DA 202443505-S179B-16 Bentham Street (Section 56 Block 22 Yarralumla)

Yarralumla Residents Association Submission

Figure 9: Demolition/Construction Materials- Areas Outside Development Site that may be used

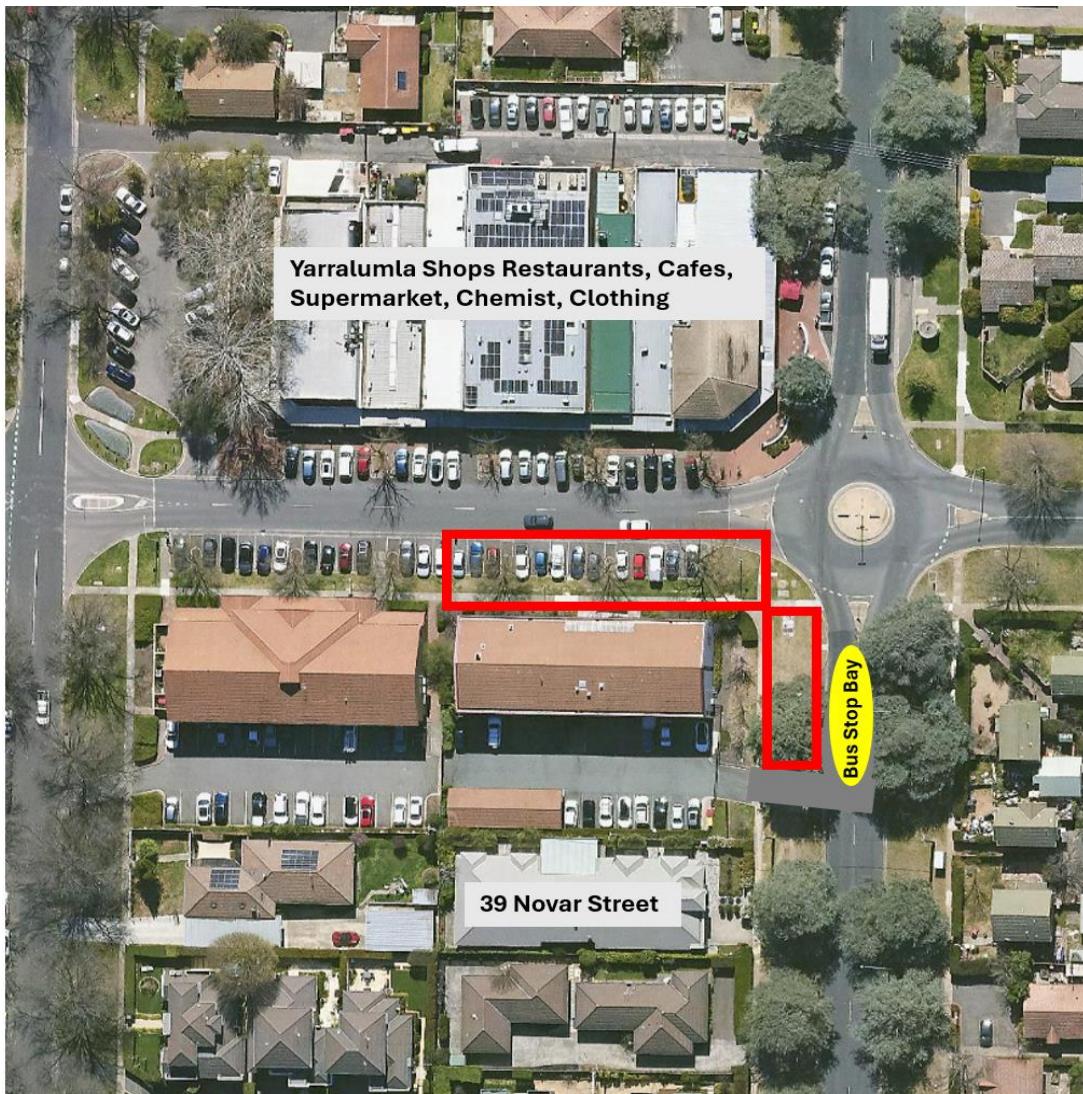
The only available areas are the Bentham Street public parking spaces at the site frontage and the nature strips on the north and east of the development. This would result in the loss of at least 13 car parks, and impact on access to and the safety of the Bus Stop. **These areas should not be utilized for these purposes as this would have major impact** on access to the Yarralumla shopping centre and its amenity (Figure 9).

Areas outside site that are likely to be appropriated for storage of demolition and construction materials, and location of site offices
